NEW YORK CITY DEPARTMENT OF CORRECTION
Cynthia Brann, Commissioner

ADDENDUM No. 5 to PIN: 072202001CPD
Powerhouse Boiler Feed Water Treatment System Upgrade

Pursuant to section §3-04 of the Procurement Policy Board (PPB Rules, the Department of Correction (DOC) is issuing Addendum No. 5 to the solicitation for the services referenced above.

Drawing No.: M222.00

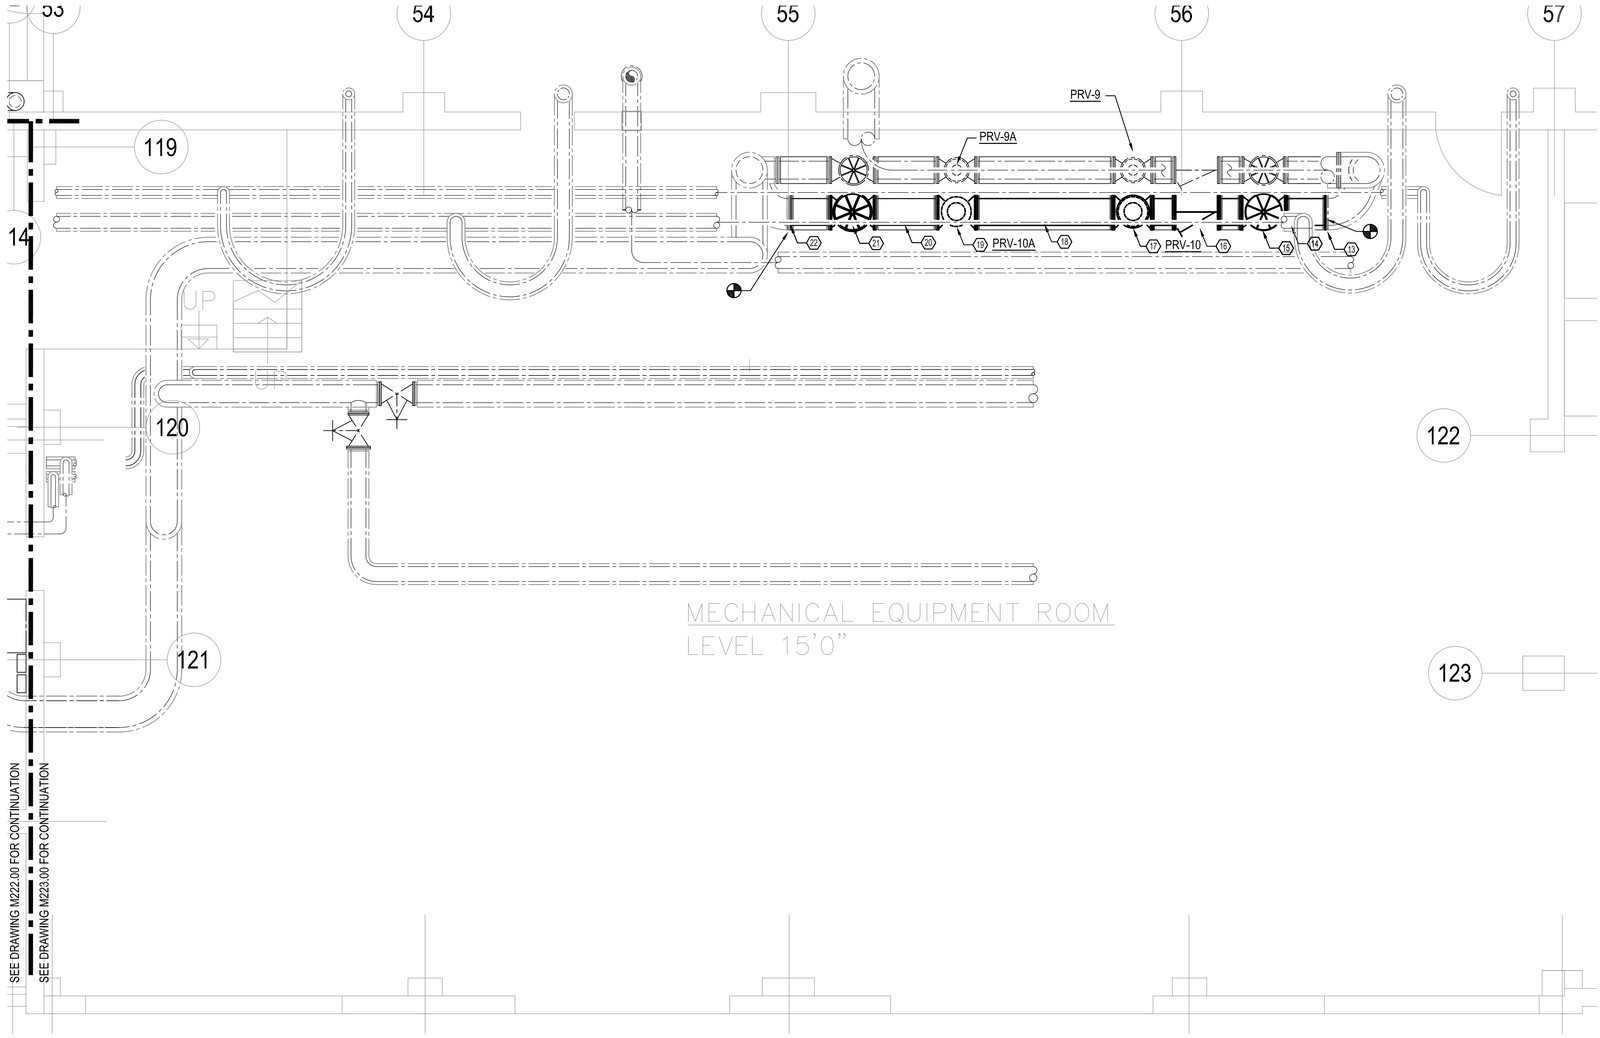
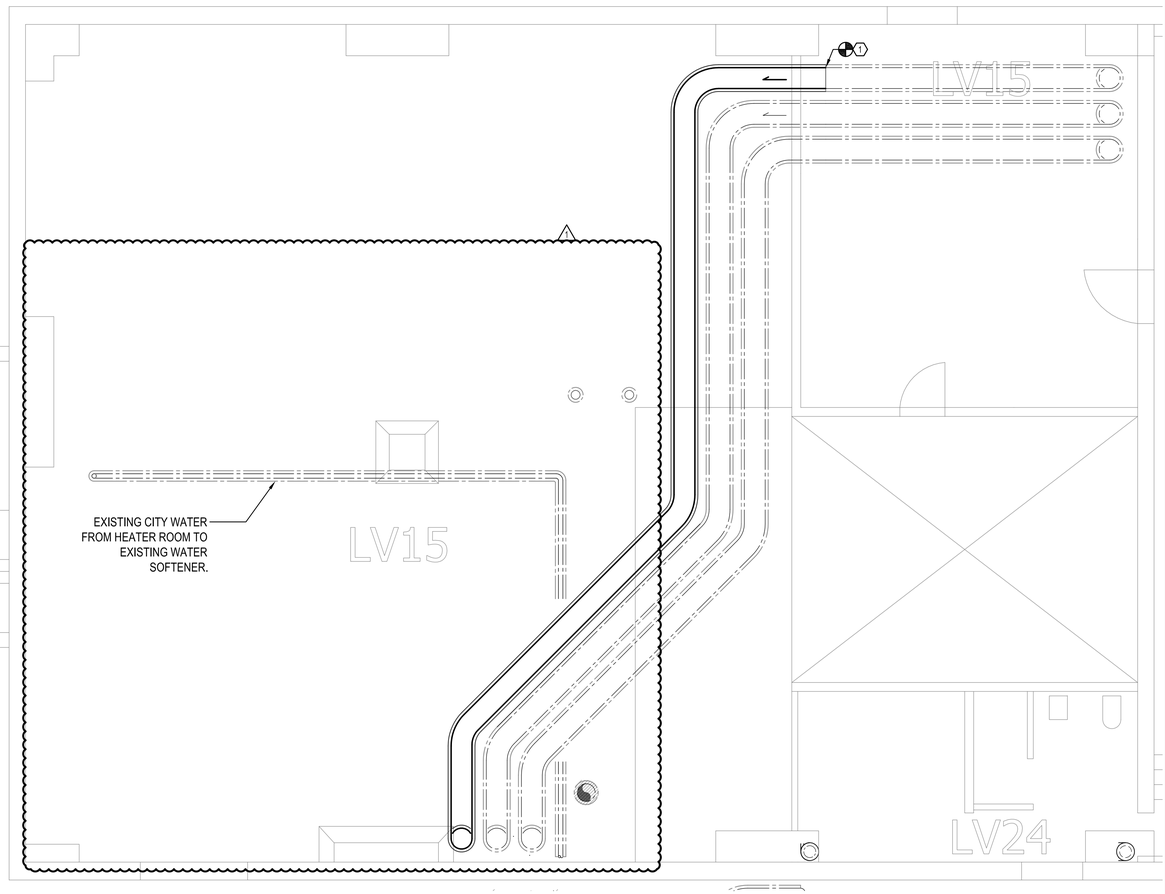
24) M222.00 – Revised RO and CIP location. Revised make up water, soft water and soft permeated water piping location. Revised tag notes.

Drawing No.:
M224.00

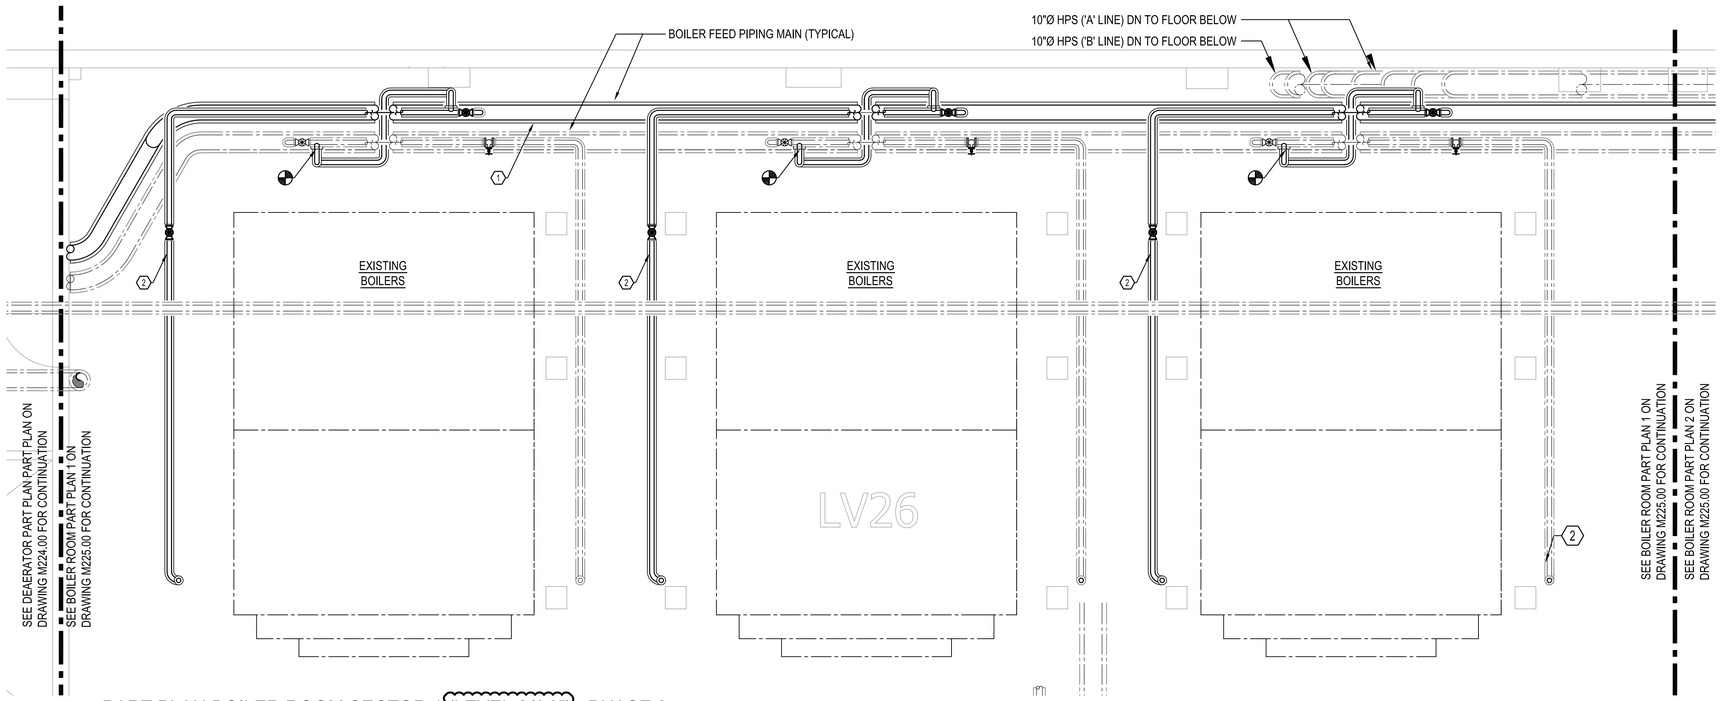
26) M224.00 – Revised RO and CIP location. Revised make up water, soft water and soft permeated water piping location. Revised tag notes.

Drawing No.:
M231.00

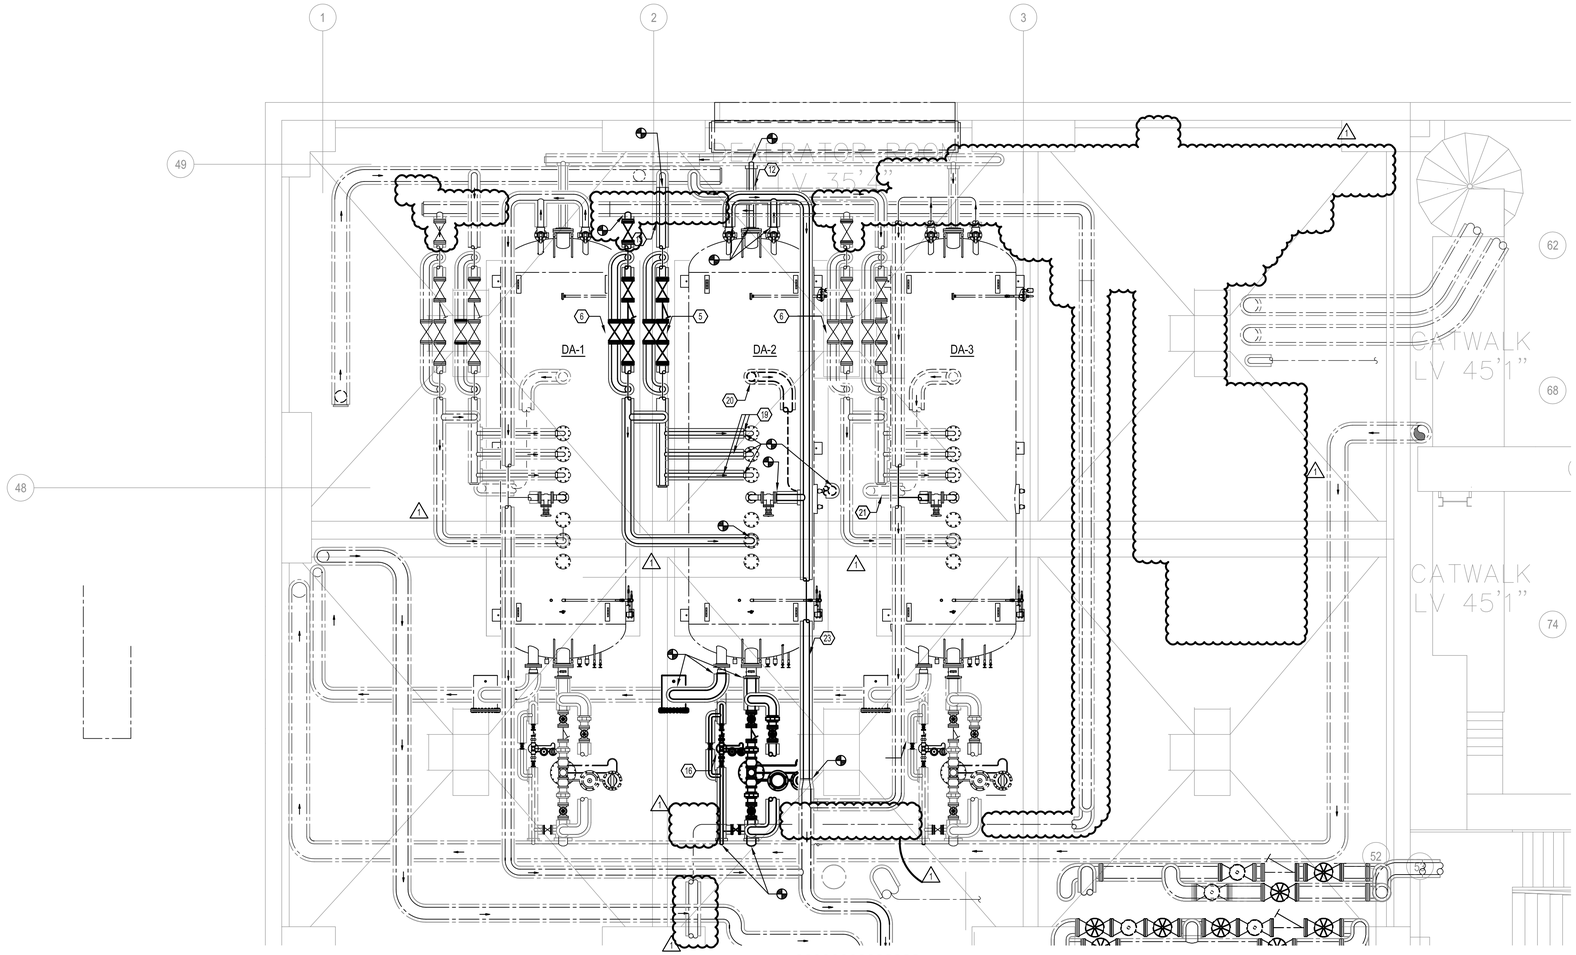
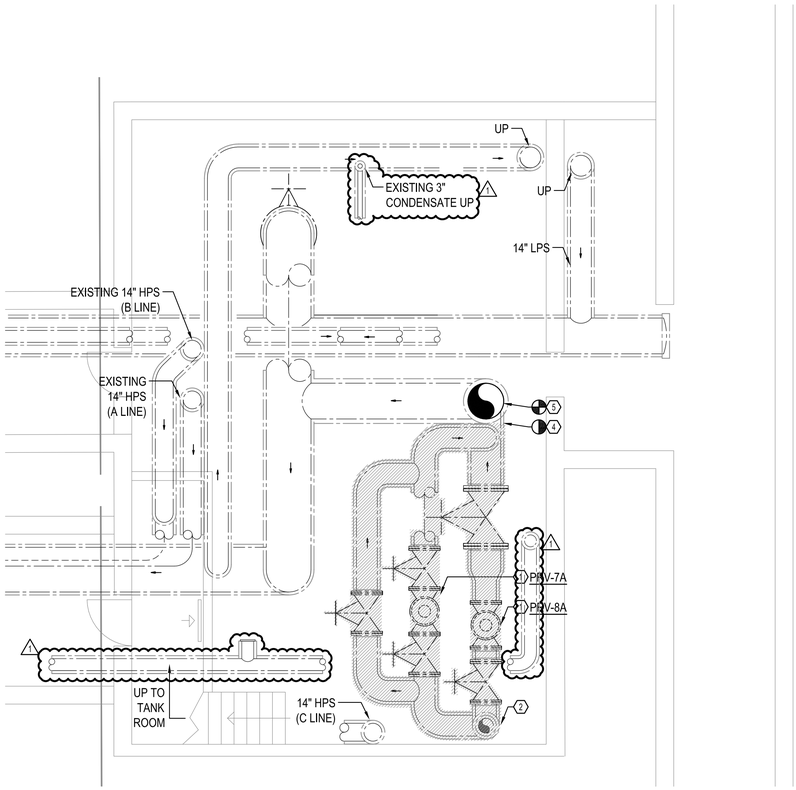
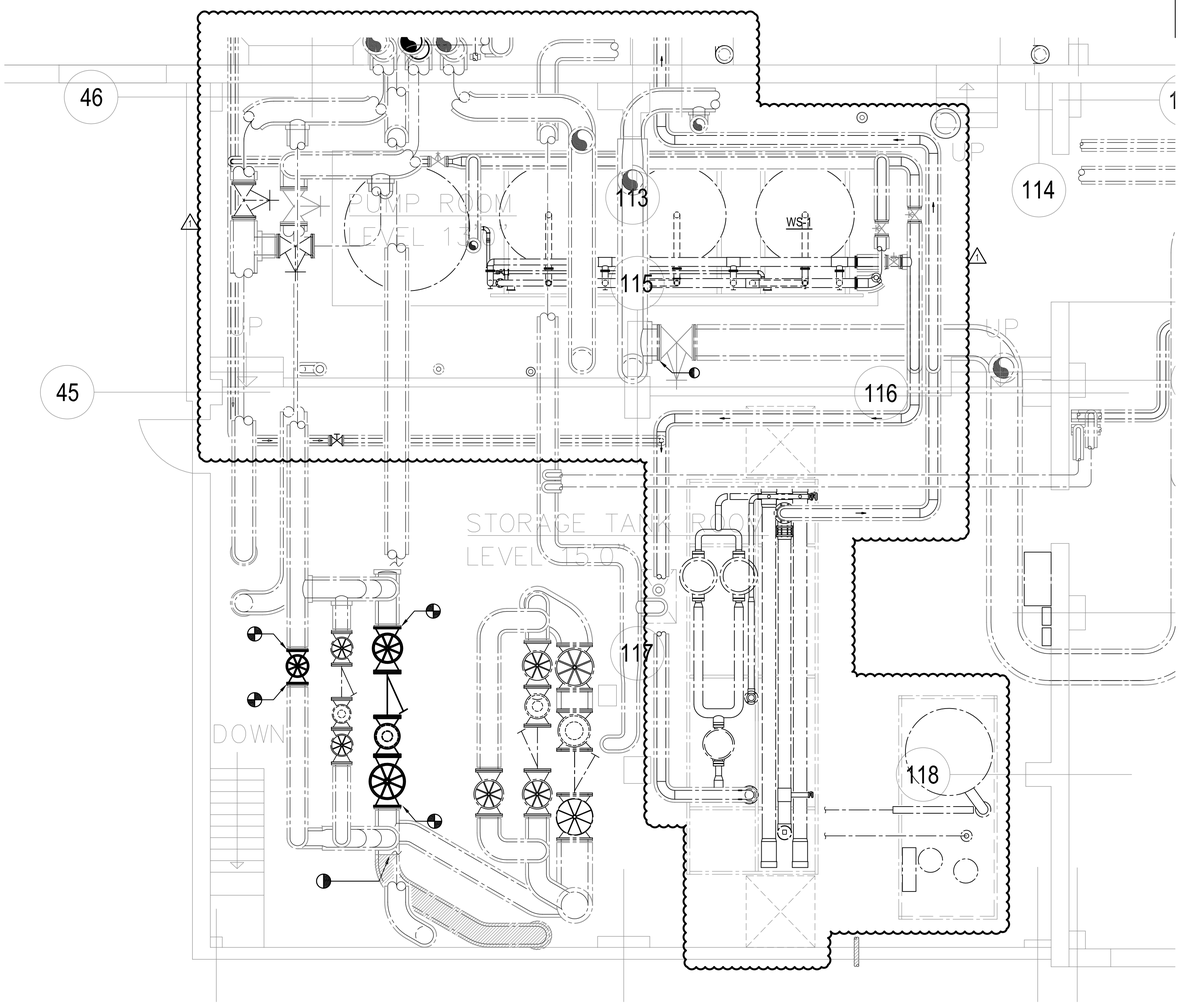
29) M231.00 – Revised RO and CIP location. Revised make up water, soft water and soft permeated water piping location. Revised tag notes.

Drawing No.:
M301.00

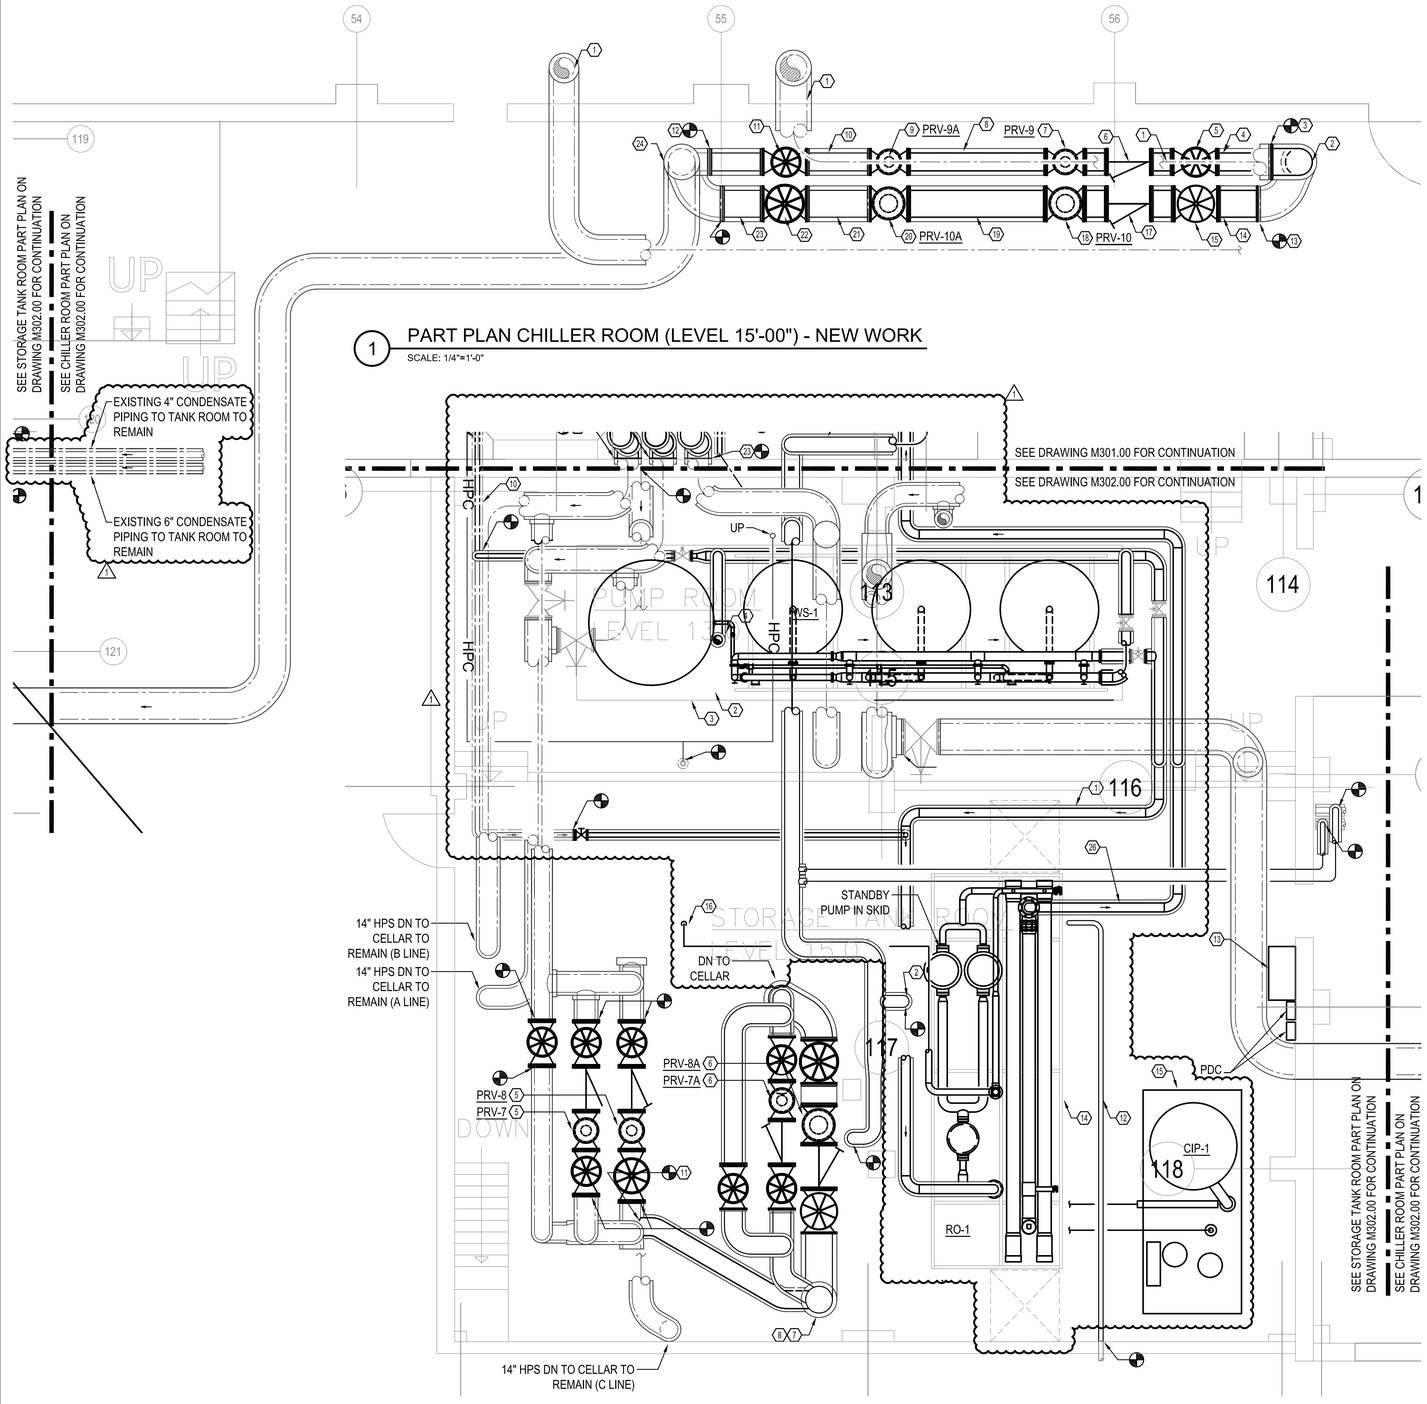
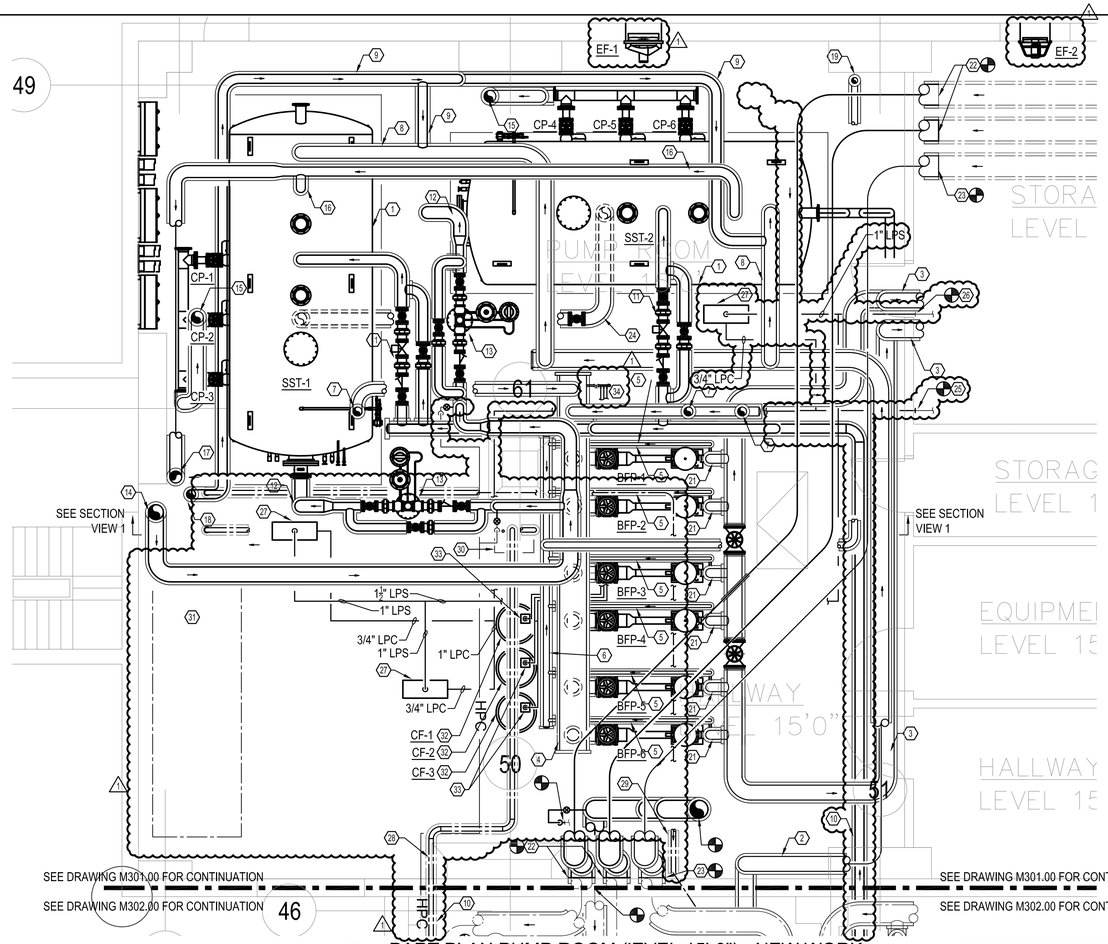
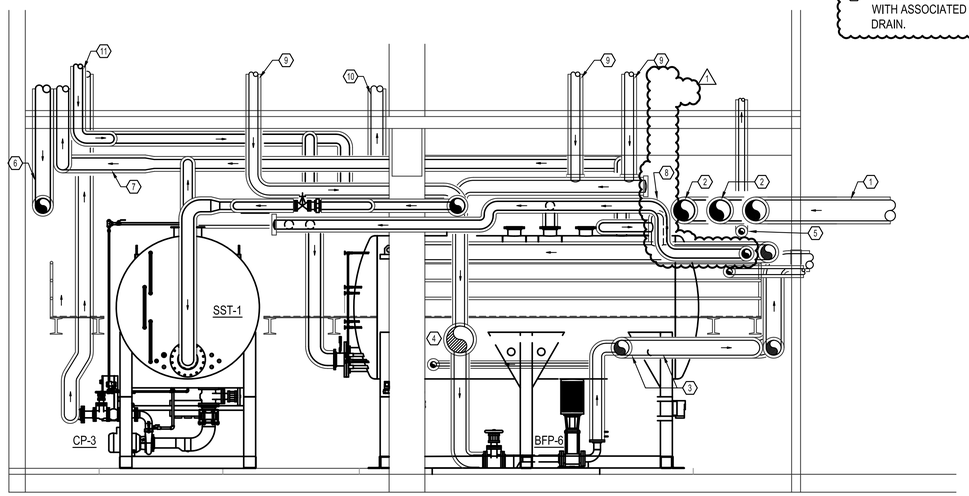
31) M301.00 – Revised RO and CIP location. Revised make up water, soft water and soft permeated water piping location. Revised tag notes.

46. Drawing M301.00 for the surge tank shows the single 6" modulating valve assembly we are controlling on each surge tank controller (total of two Surge tanks)

68. As per drawing M-301.00 note 1 and 2, do you mean to use the word "Install" instead of "Installed" under "Scope of Work On this Drawing"? It is confusing as this sentence makes it seem as the items following that word have already been installed. We would like clarification as to the scope. The same could be asked for M-302.00 and M-303.00 Scope of Work Sections throughout the M drawings. M-301.00 was used as an example.

69. As per drawing M301.00 part plan 3, there are aren't any symbols that explicitly dictate where the new work begins and ends. It seems to show only bolded valves and fittings are to be replaced. This is also true for drawing M-303.00 part plan 1. Can you please clarify.
